DESIGN POOR PRACTICE – Clearance around CHW brackets

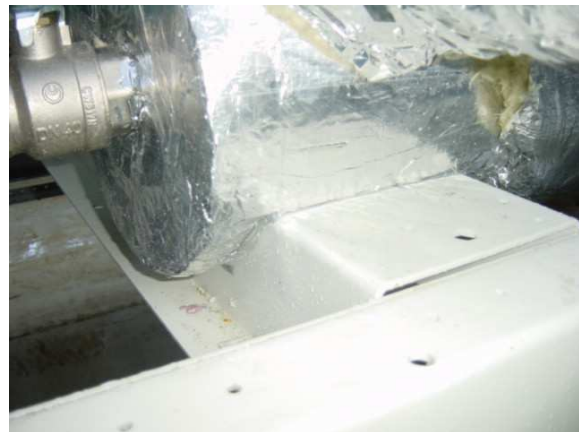
Poor design of the pipework system around brackets and unistrut framework on a Chilled Water system means that clearance for the insulation is insufficient and unless the insulation thickness can be applied to the manufacturers specification, a vapour seal cannot be achieved and the system will continuously cause condensation “sweating” and corrosion.

- However good the workmanship, any attempt to create a vapour seal around the pipework / fitting is futile and a cold bridge forms causing condensation & therefore corrosion will occur.
- The efficiency of the Chiller Unit will be affected (causing energy loss) as the chiller will be over compensating for the lost “cold” around the affected area.
- The cold bridge allows moisture into the vapour-sealed system and can cause extensive corrosion requiring remedial / replacement works.
- If Design Engineers were to liaise with the insulation contractor at early design stage, these issues could be designed out and increase the efficiency of plant and reduce issues on-site which cost time & money.
